Access Compliance Report

Public Rights-of-Way

(Curb Ramps)

Intersection ID: 13476	Main Street: ELIZABETH_AV	Cross Street: PEASE_LN	Location: NE
ADA ID: 81AF9062A8D8	Ramp Type: Perp	Initial Pass/Fail: Pass	Overall Compliance: No
		Severity Score: 0.25

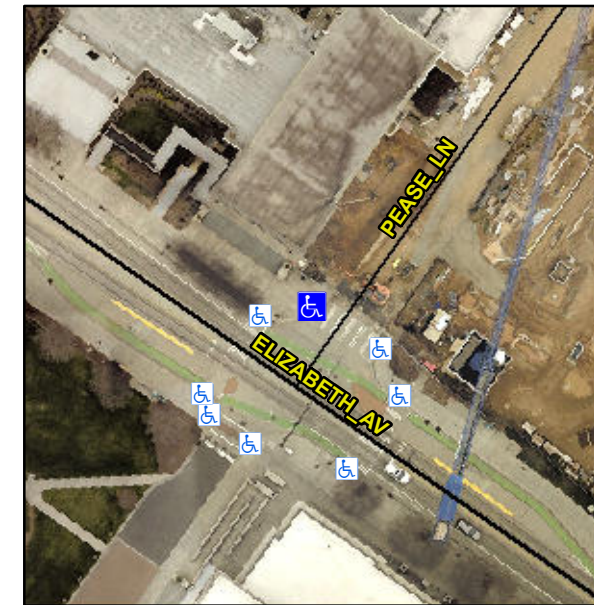
Not Found, R304.5.3, R304.2.2-Perp, R304.3.2-Para

Compliance	Description	Data	Compliance	Description	Data
N/A	Ramp Length (in)	72.0	Yes	Ramp Slope (%)	5.9
Yes	Ramp Width (in)	48.0	No	Ramp XSlope (%)	3.9
N/A	Flare Type LT	Sloped	N/A	Flare Type RT	N/A
N/A	Flare Slope LT (%)	7.5	Yes	Flare Slope RT (%)	1.9
N/A	Flare Traversable LT?	Yes	N/A	Flare Traversable RT?	Yes
Yes	Landing Length (in)	89.0	Yes	DWS Provided?	Yes
Yes	Landing Width (in)	48.0	Yes	DWS Contrast?	Yes
No	Landing Slope (%)	3.3	Yes	DWS Length (in)	24.5
Yes	Landing X Slope (%)	3.6	Yes	DWS Full Width?	Yes
N/A	Landing Curb? (Y/N)	No	Yes	DWS Offset (in)	2.0
N/A	Shared Landing?	No			
Yes	Gutter Ponding?	No	Yes	Gutter Slope (%)	2.7
Yes	Gutter Lip Ht (in)	0.0	Yes	Gutter X Slope (%)	3.3
N/A	Painted X Walk1?	Yes	N/A	Painted X Walk2?	N/A
	X Walk 1 Direction	To SE		X Walk 2 Direction	N/A
N/A	X Walk 1 Width (in)	158.0	N/A	X Walk 2 Width (in)	N/A
	X Walk 1 Slope (%)	3.0		X Walk 2 Slope (%)	N/A
	X Walk 1 X Slope (%)	3.7		X Walk 2 X Slope (%)	N/A

Remove & Replace Entire Ramp.
